## 1310 nm serial Back Reflection

# 1310 nm serial Back Reflection Objective

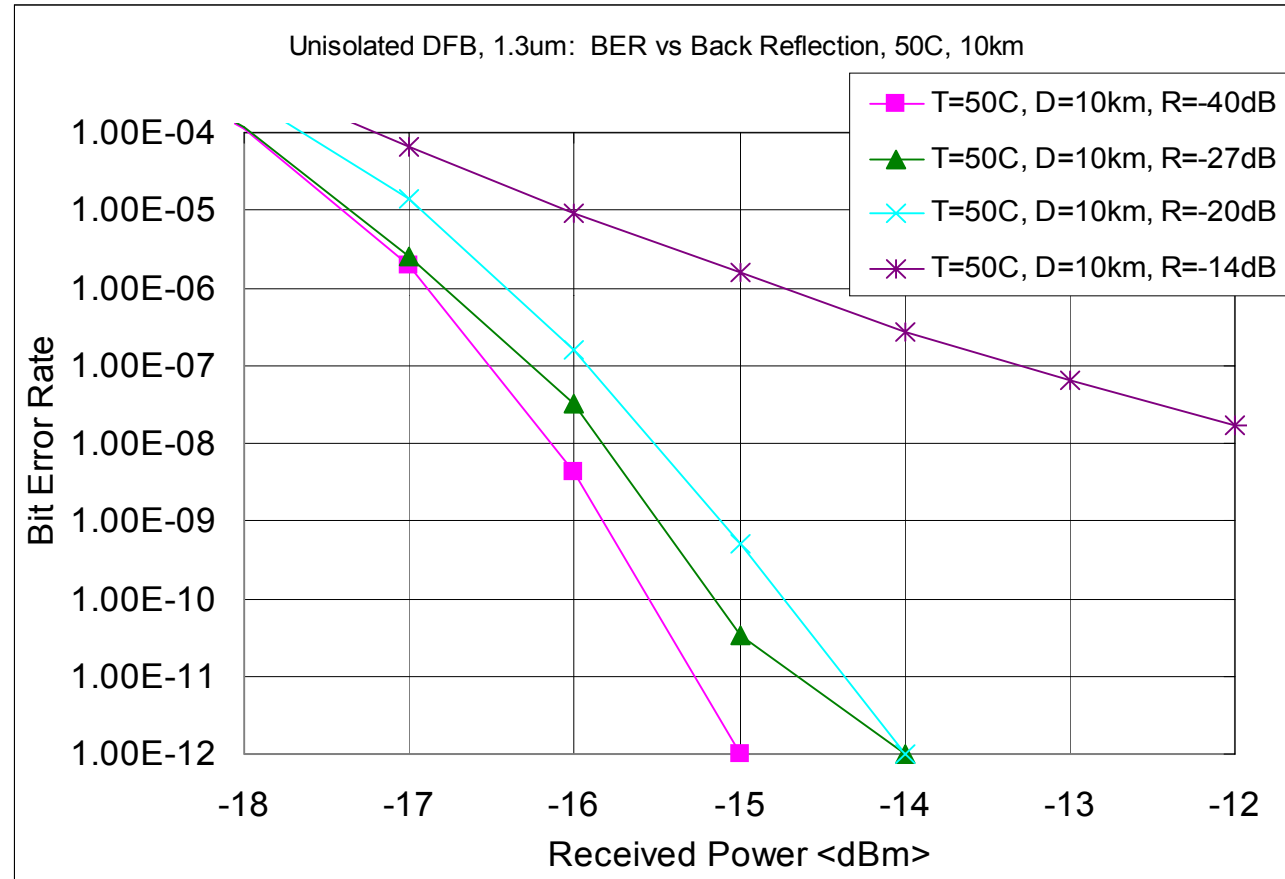
- Objectives:
  - Create low cost 1310 nm Serial links
  - Create specifications which interoperate between vendors
  - Specifications which allow multiple technologies
  - Design a robust PMD link with low RIN and low jitter
- The history of the existing 12 dB spec stems from 1G links on 850nm MMF with simple FC connectors. These were immune to reflections and were designed without pigtail fibers for the connectors.
  - Pigtails with mating connectors are a requirement with SMF due to alignment tolerance of fiber
  - Mated connectors (SC or FC/PC) required at 10G rates; an air gap connector is unacceptable
